3 Volt Intel[®] Advanced+ Boot Block Flash Memory

28F800C3, 28F160C3, 28F320C3, 28F640C3

Specification Update

Order Number: 297938-014

1. 28F320C3xC Maximum I_{CCE} when $V_{pp}=12V$

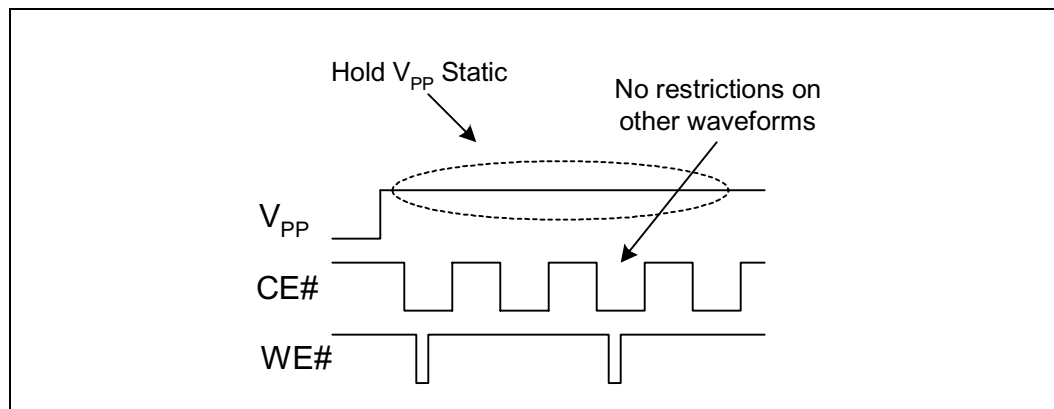
Problem: When $V_{PP}=12V$, I_{CCE} Max on 28F320C3xC devices on the 0.18 μ m deviates from the published specification and increases from 15mA to 25mA. The following is the revised specification for these products.

Implication: The increased current requirements may result in increased power drawn from the power supply during limited 12 V production programming. 3 V programming is unaffected.

2. 28F320C3xC Reset Failure

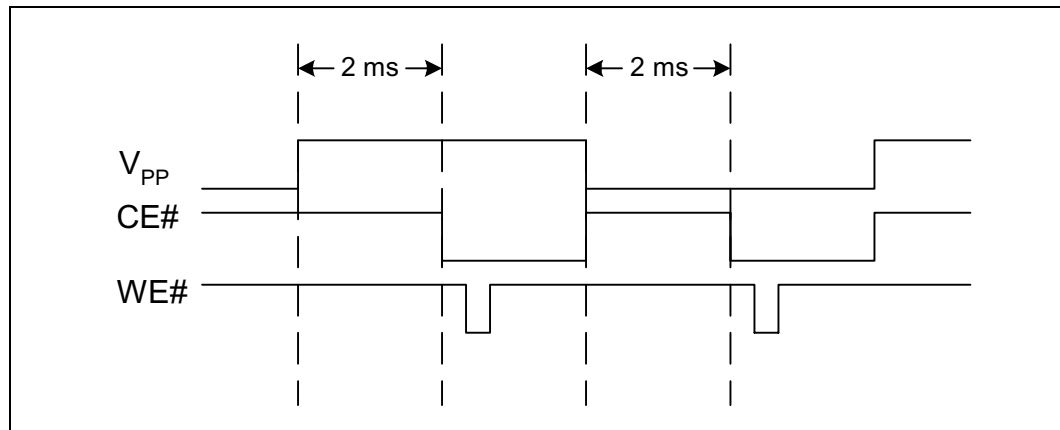
Problem: The 0.18 μ m 28F320C3xC devices can unintentionally reset under certain conditions where V_{PP} toggles.

Implication: When the reset occurs, any command being executed is interrupted and the flash switches to read array mode.

- 1) Tie V_{PP} to V_{CC} ;
- 2) If the third and fourth digits on the top side FPO mark (third line) is equal or greater than “23”, then V_{CC} may be set from 2.7v to 3.3v. V_{CC} must not exceed 3.3v
- 3) Set V_{PP} to a static high or static low level as shown here; and

4) Wait 2 ms after a V_{PP} transition to access the flash device, as shown here.

Figure 1. Workaround Placement

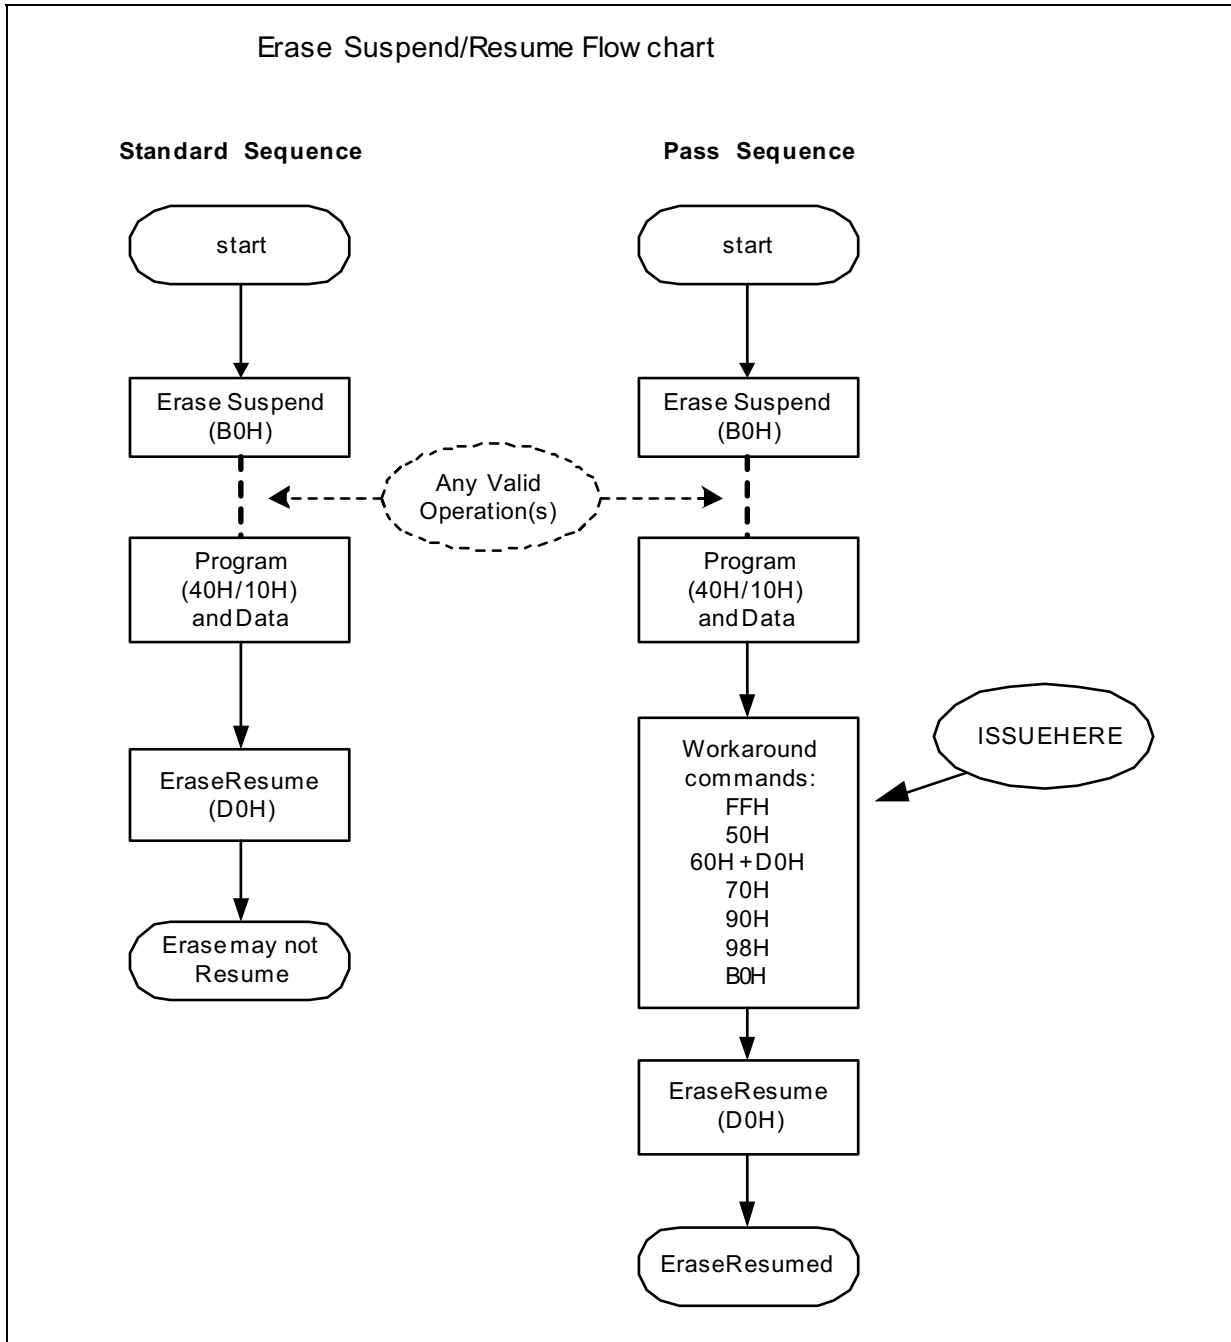
Problem: On the 0.18 μ m 28F160C3xC devices, a design anomaly was discovered. During an Erase-Suspend operation, if the Program (40H/10H) sequence is executed, under limited conditions the proceeding Erase Resume command (D0H) may not actually resume the device. No customers have reported failures in product applications. Customers who use any version of FDI (Intel Flash Data Integrator) software will not see this issue. If the Read Array command is issued prior to the Erase Resume command, users will not see the issue (typical in XIP applications).

Implication: The Resume Command (D0H) may be ignored by the device and will not correctly resume. The device will appear to remain in suspend (via status register). After a reset of the flash device the status register will clear. This failure has been recreated in a lab environment only.

1. If FDI (Intel Flash Data Integrator) software is used, users will not see the issue.
2. During an Erase-Suspend (B0H), user must issue any of the following commands after issuing the Program (40H/10H) and data sequence but before issuing the Erase-Resume (D0H) command.

5. 28F160C3xC and 28F640C3xC Lock/Unlock/Lock-Down Operation

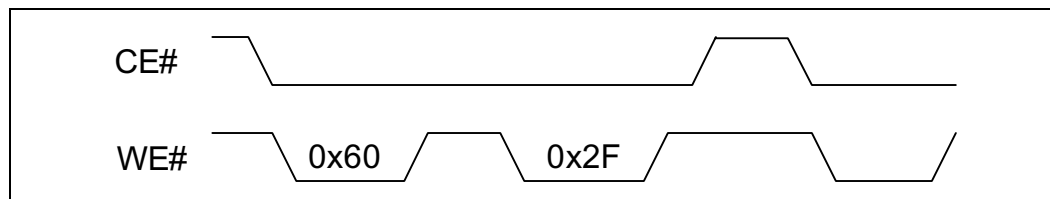
Problem: On the 16Mb and 64Mb 0.18 μ m devices, if CE# is deasserted after any block lock operation and before the next write sequence, the part may perform the same operation on additional blocks. (See waveform below.)

Implication: When CE# is deasserted after performing a block lock operation to a specific block and prior to the next write sequence, other blocks may perform the same operation.
